PNG (BD) LTD

Korerhat, Shattaroa, Jorargonj, Mirsharai, Chittagong, Bangladesh

9th January, 2018

Observations

Vertical bracing layout

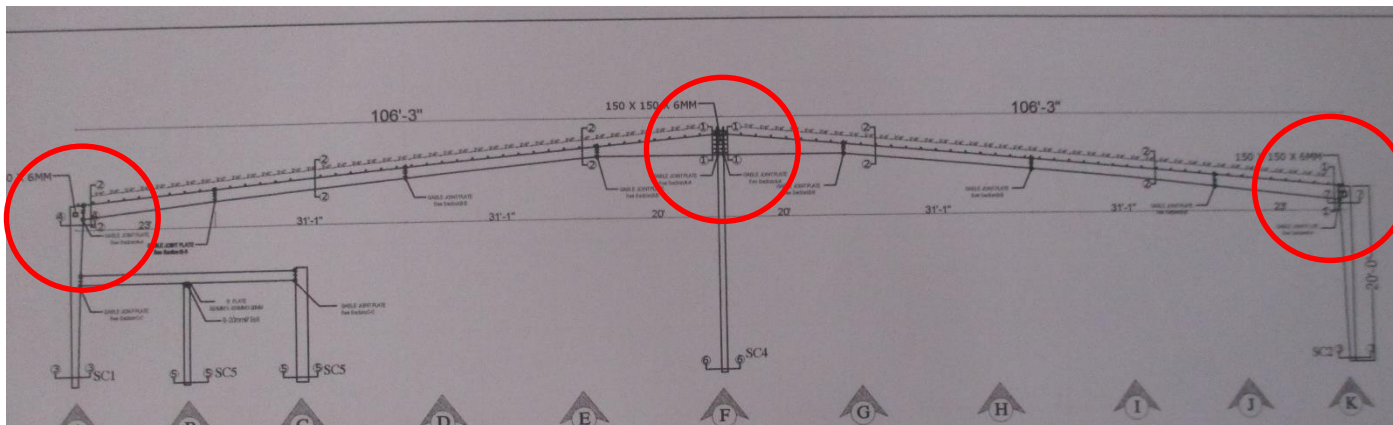
Vertical bracings have designed as stability system against lateral loading. On site no vertical bracings were installed.

No vertical bracing on site

Frame sectional drawing

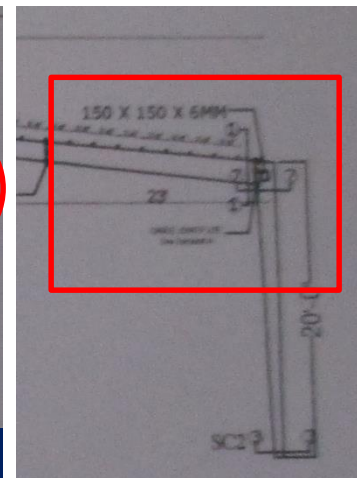
Missing strut member in eave level

Vertical bracings and struts members are part of lateral stability system. Vertical bracings and strut member at eave points were not installed as per drawing. Building engineer is required to check the lateral stability of the shed considering lateral forces as per BNBC provision.

Significant gaps and missing bolts at several connections

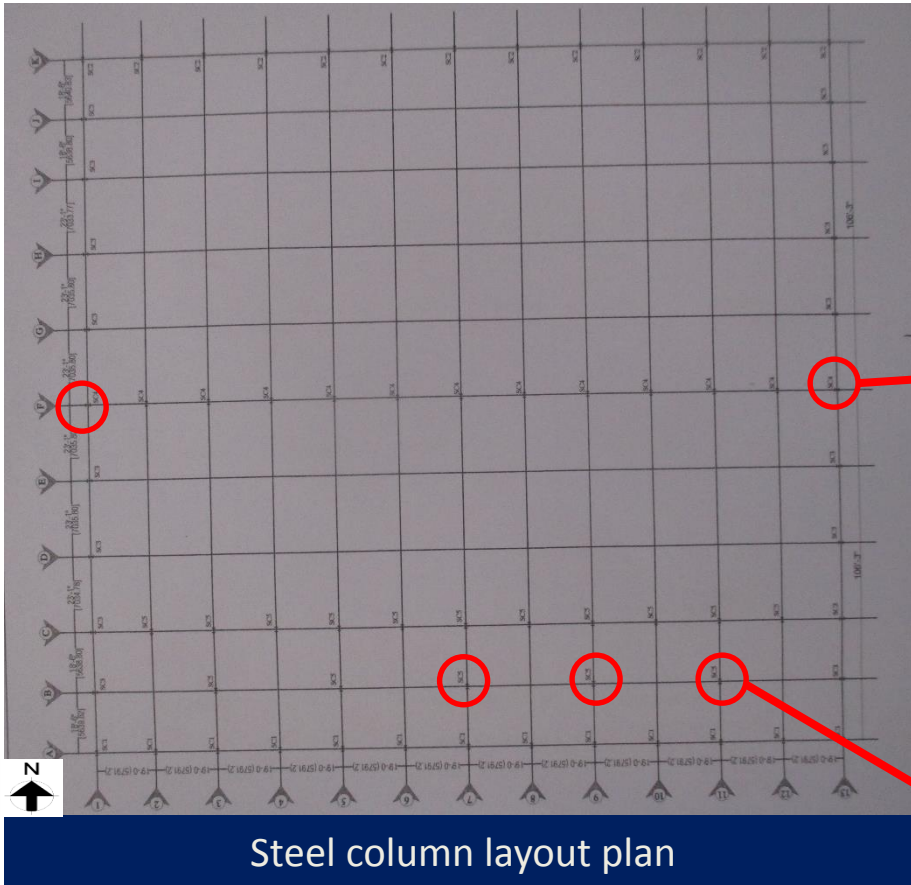
Bolts missing in several location

Existence of significant gap at connection

Significant gaps and bolts missing were observed in column rafter joint at several location. Building engineer is required to carry out suitable remedial works.

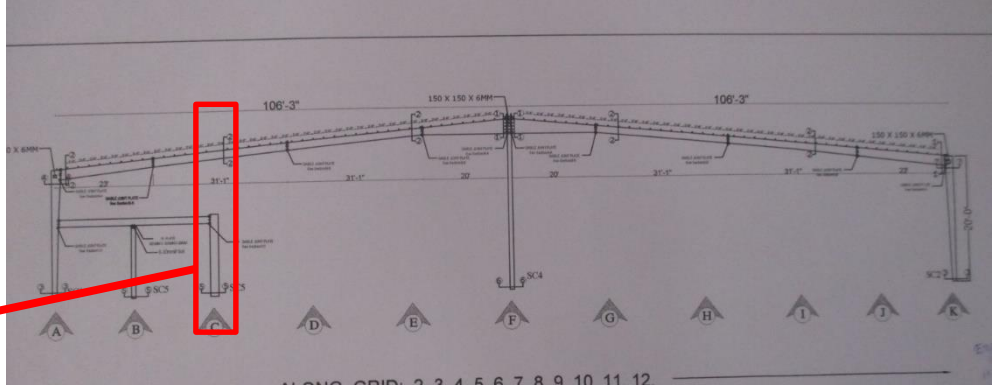
Column extended up to rafter with pin head not shown on drawing.

Section drawing

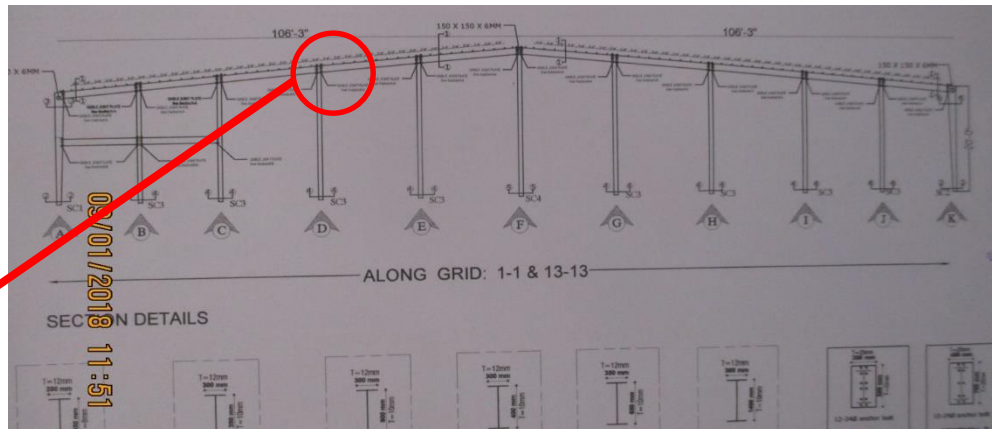
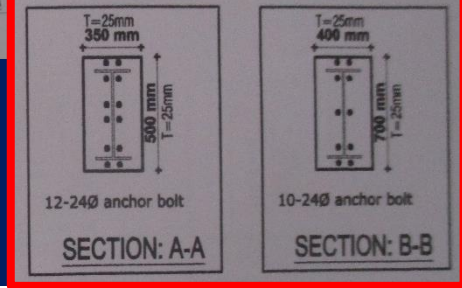
Connection of end frames are moment connection as per drawing. Onsite pin connection observed.

Change of connection type

Vertical bracing layout

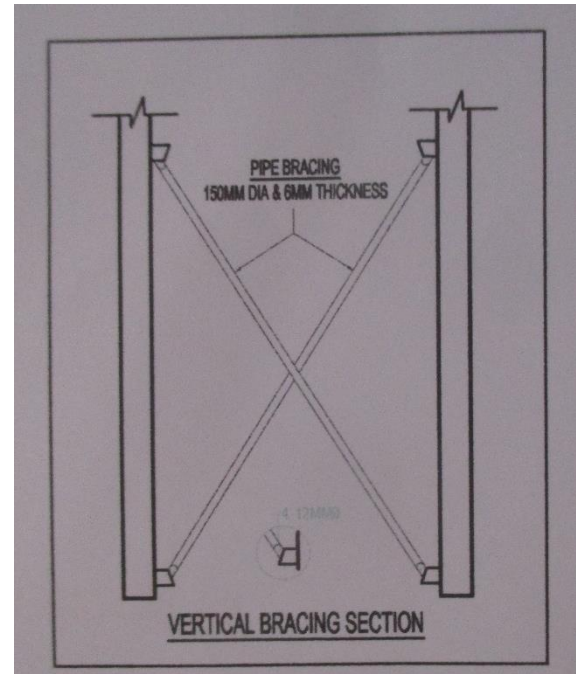
Vertical bracings have designed as stability system against lateral loading. On site no vertical bracings were installed.

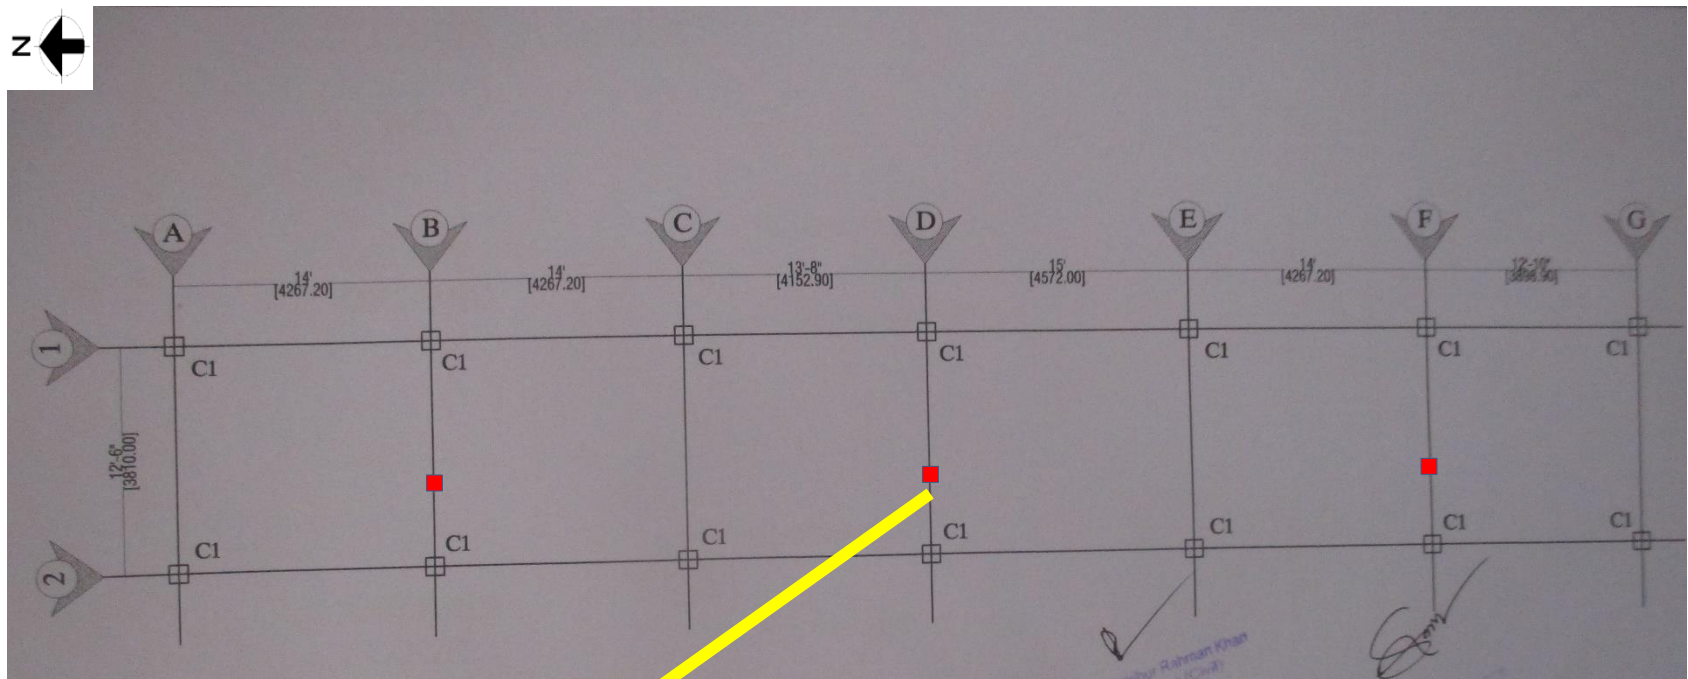
No bracing system was installed.

No structural drawings were available.

Apparently no lateral load resisting system was observed on canteen shed. Building engineer is required to check the lateral stability of this shed.

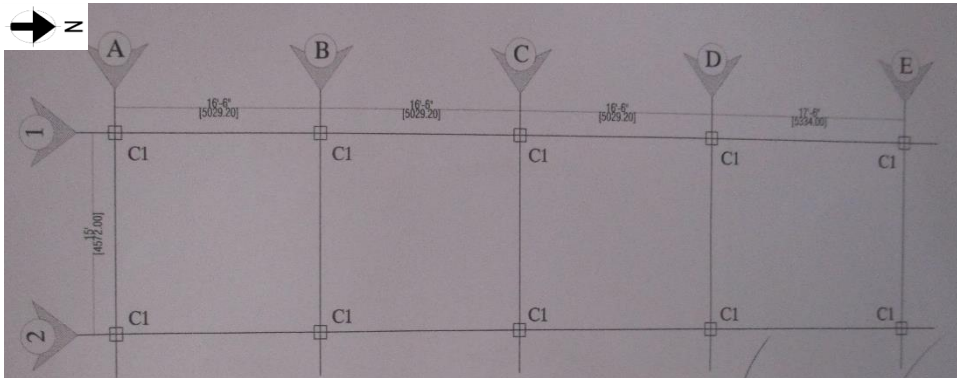
Column layout, number of rebar in column and grid dimension did not match with drawings. Red marked columns are not shown in drawings. 8 nos. of rebar were found in each column instead of 10. on drawings.

Scan result

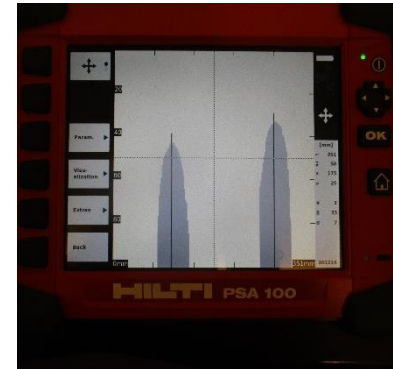
Nos of rebar in column and grid dimension did not match with provided drawings. 6 nos. of rebar were found by Ferro scanning in each column instead of 10.

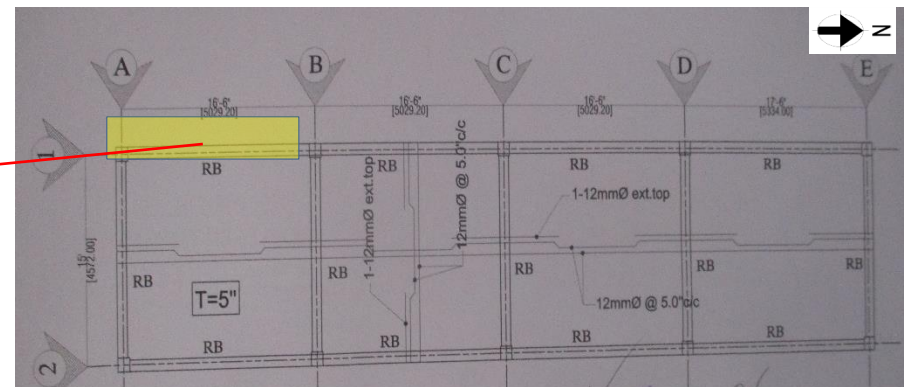
Slab layout did not match with drawing. At west extended portions are not shown in drawing. Also, beam slab are shown in drawings whereas flat slab was found.

Flat slab

Extended slab

Column Layout of Prayer Building

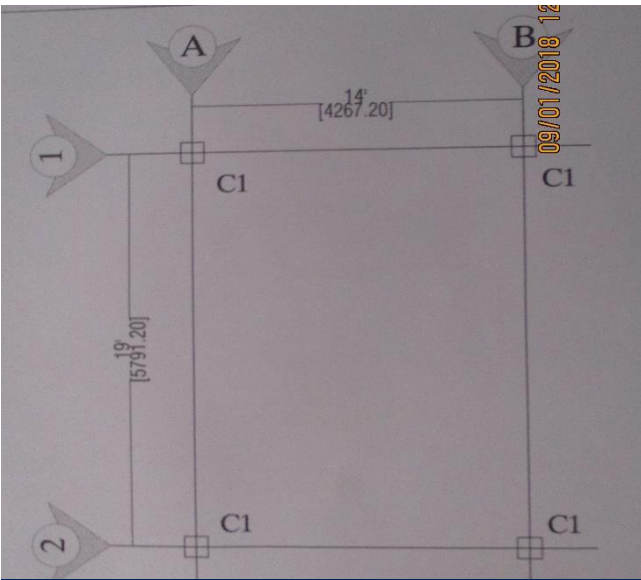
Orientation of column and grid dimension did not match with drawing. Also no over head RC water tank details were found.
